**Utah Fuel  
Company**

Re: Scofield Rock Waste Disposal Site

SCOFIELD ROCK WASTE DISPOSAL SITE

1 Responses to UDOGM Letter of July 2, 1982 .....	86
---	----

Figure 1. Vegetation Communities of Proposed Waste Rock Disposal Area (T13S, R7E). SCALE: 1" = 500'

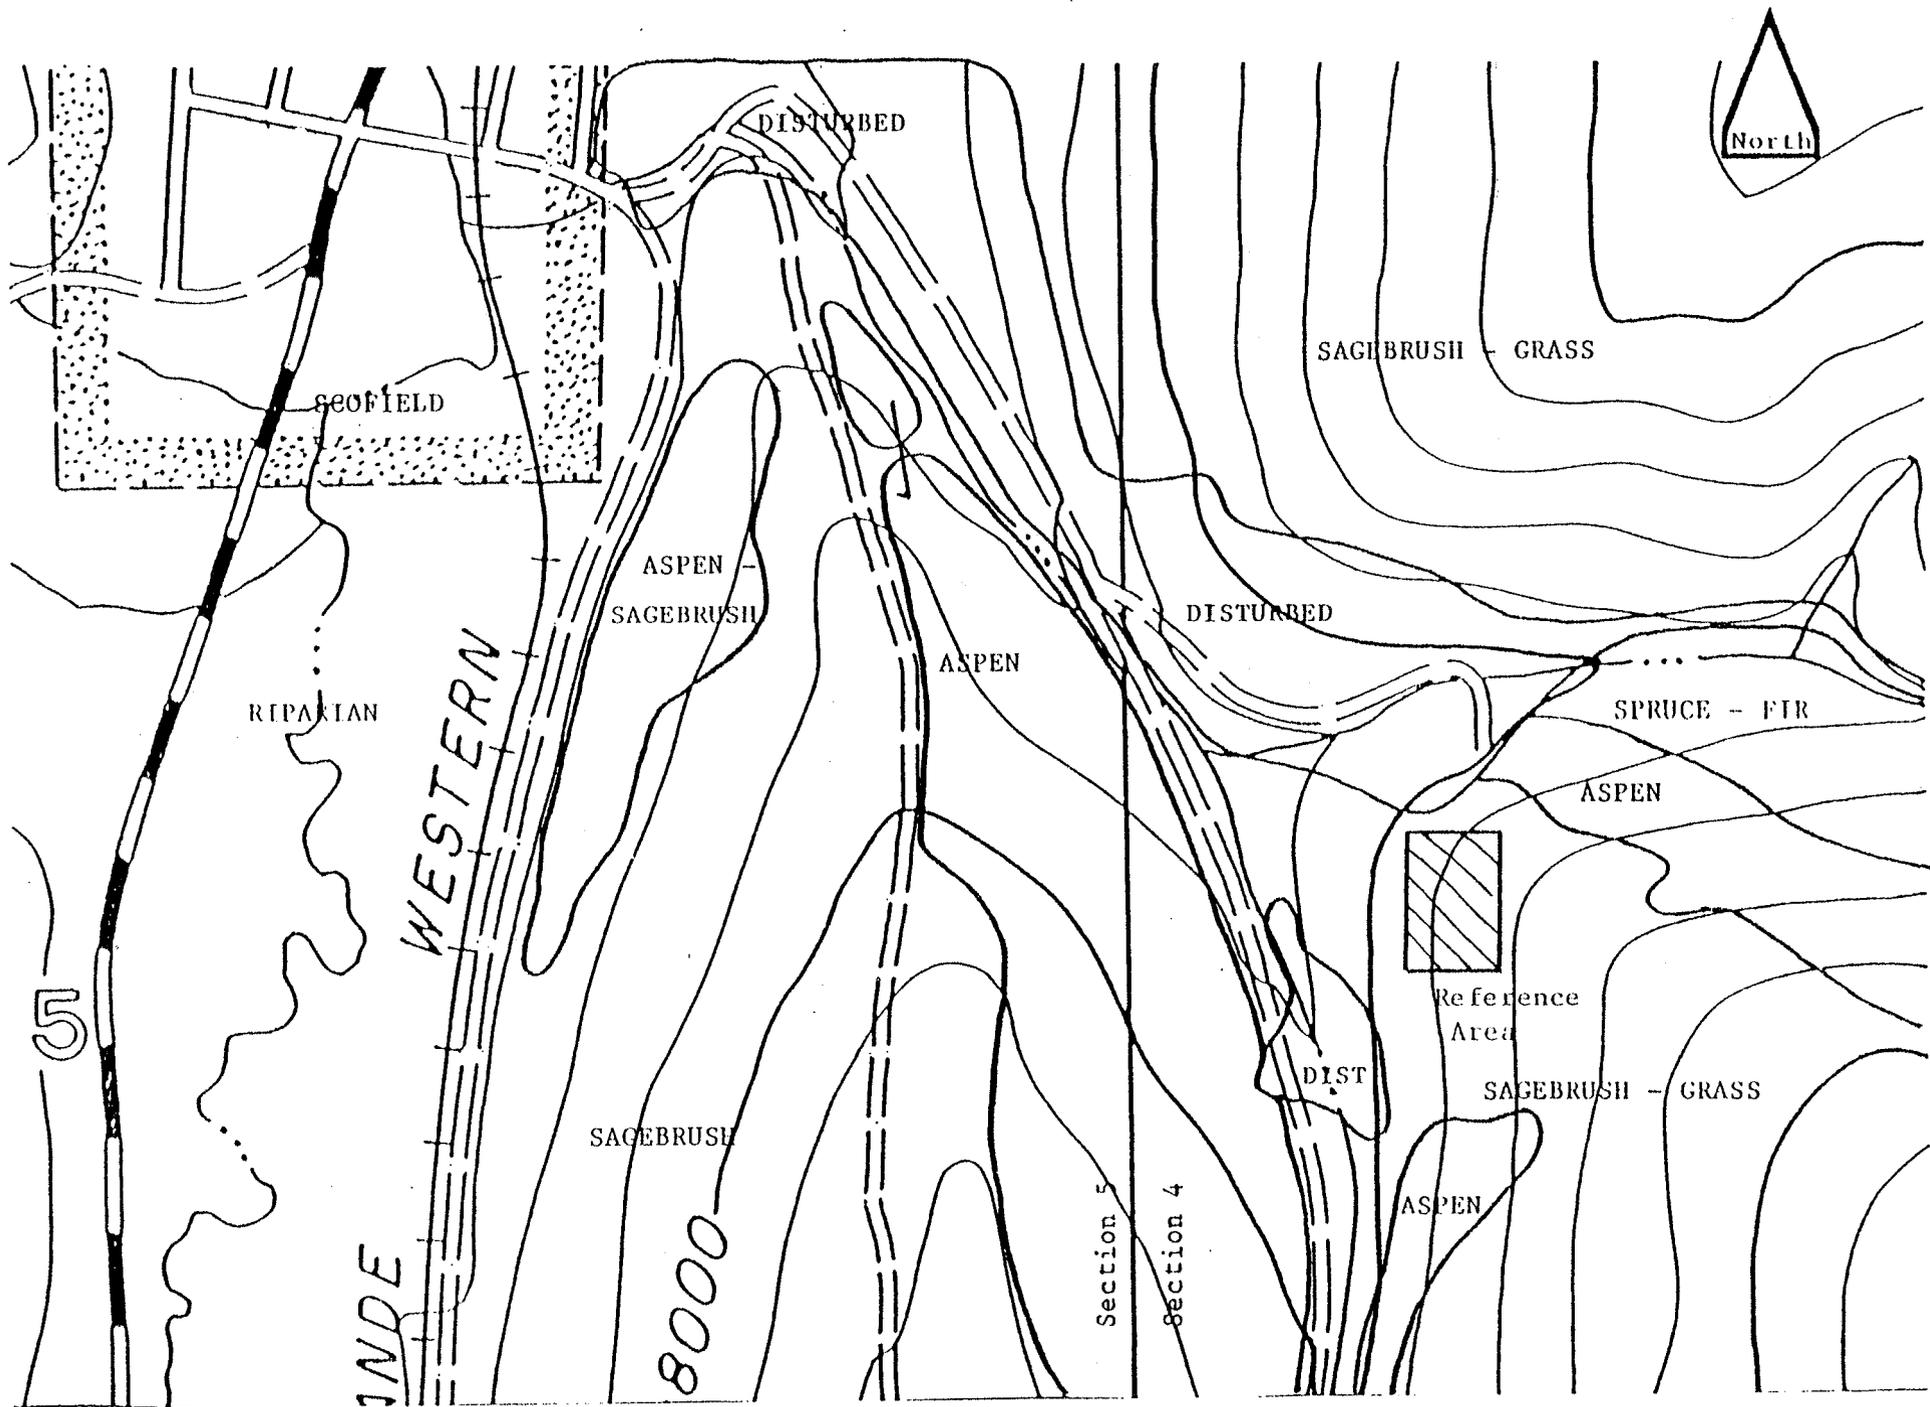
It was recommended that the Division be furnished with a vegetation map which depicts the previously disturbed sites to be affected and the adjacent vegetation communities, particularly if a reference area is selected and sampled within the adjacent community. A reference area was sampled near the proposed site and a map indicating the vegetation communities of the area is included in this report as Figure 1.

If the area is to be reclaimed to native rangeland and a new reference area is selected to serve as a standard for revegetation success, statistically adequate, quantitative data pertaining to cover and woody plant density, as well as a statement of productivity, should be supplied by the Applicant. It should be noted that the tree density survey contained in the Application is questionable in that the need for tree density data is dubious if the area will be reclaimed to a shrub/grassland type or improved pastureland. It is also inadequate in that transects were not placed so as to restrict specific sampling units to individual vegetation types, but were placed so as to cross all three communities. This yields an overall estimate for the area surrounding the proposed disposal site, but very little information about any given vegetation type. In addition, the Applicant has defined the sampling points along the transect as the sampling units, whereas the transects, and not the points along the transect, are the sampling units, thus sampling adequacy computed incorrectly.

The Applicant has included a consultant's response to the vegetation information questions with Appendix 2.

The response includes a vegetation map and quantitative data pertaining to cover and woody plant (shrub) density as well as a statement on productivity.
